DATE: October 1, 2024  
TO: Potential Respondents  
FROM: Elaine Robbins – Construction Contract Expeditor II  
SUBJECT: Questions #1  
RFCSP769-25-992ER  
UNTHSC Gibson Library 3<sup>rd</sup> FI Provost Suite

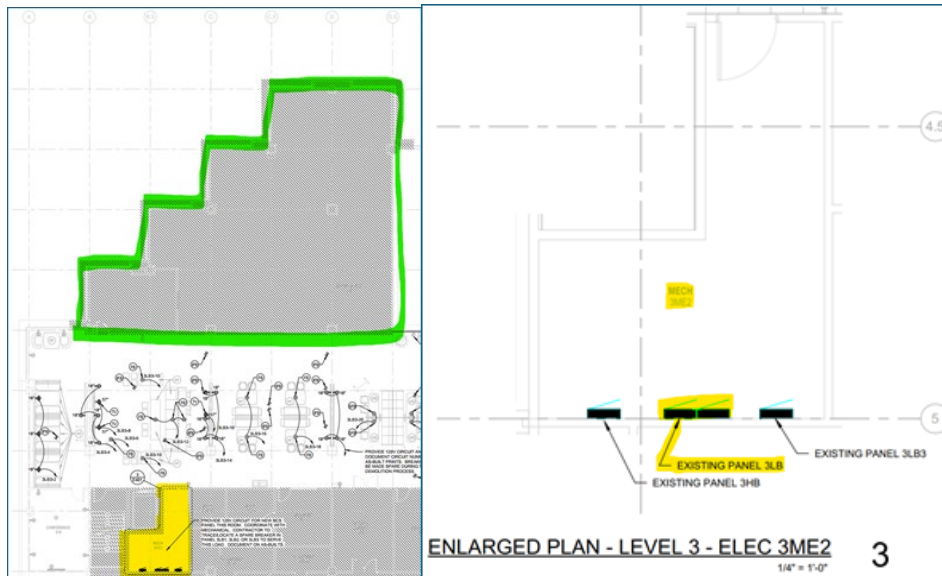
- 1) We noticed on the prints we are supplying panel “3LB-4” from existing panel “3LB” in electrical room “3ME2”. From our Site visit, and in the pictures we obtained, we have panel “3LA”. Is “3LA” the correct panel, or are we possibly coming from a different electrical room? Or can we confirm which 3LA panel is the correct one?

The electrical room included the following panels (2.3LA panels)”

- 3LA (Feed from Panel DLA)
- 3LA (EC: Fire Alarm/ECS)
- 3HA

**ANSWER: 3LB is the correct reference 3LA is on the opposite end of the building. See next page for photos.**
